Service Bulletin

Bulletin No.: PI1203A

Subject: Information on Steam/Vapor Coming from Front Grille or Radiator Area

Models: 2014 Chevrolet Impala (VIN 1)

3943556

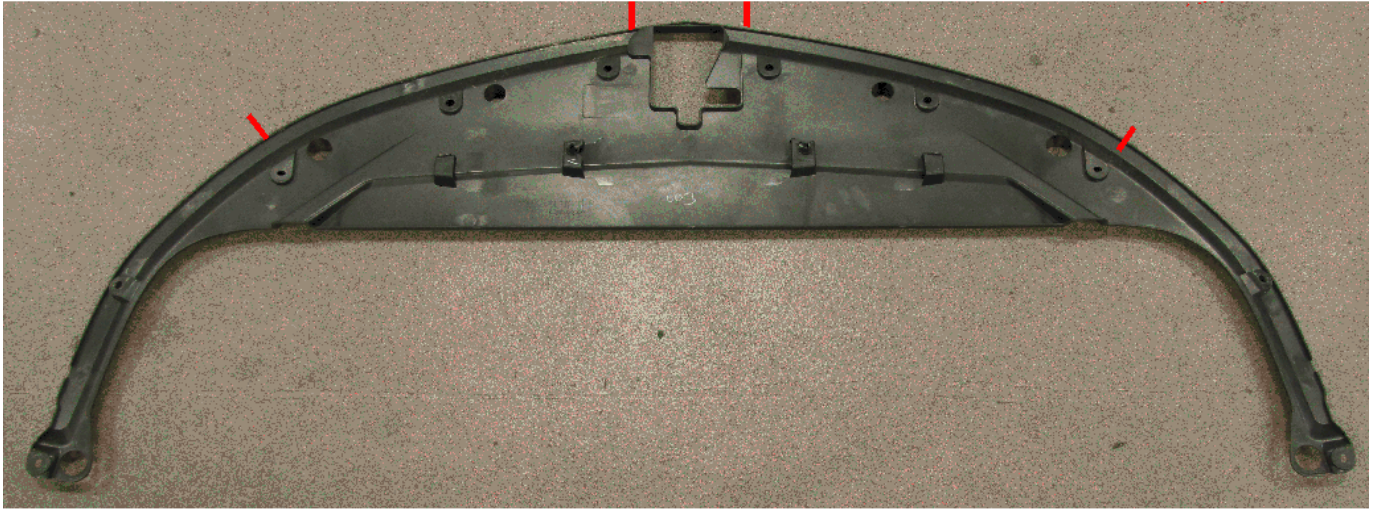
Some customers may comment that steam is coming from the front grille at idle, or on seeing vapor coming from the radiator after car washes.

The cause of this condition may be the result of rain or car wash runoff water reaching the condenser, radiator and fan module (CRFM) where it can be vaporized and, with the right weather, can become visible condensate.

Apply BRS tape to the front compartment front sight shield front lip and replace the radiator air upper baffle and deflector following the procedure below.

2. Cut two pieces of BRS tape 425 mm (17 in) and peel the backing off. Place the adhesive side along the marked area on the front sight shield front lip as shown in the illustration above.
3. Replace the radiator air upper baffle and deflector with the revised part number listed below. Refer to Radiator Air Upper Baffle and Deflector Replacement in SI.
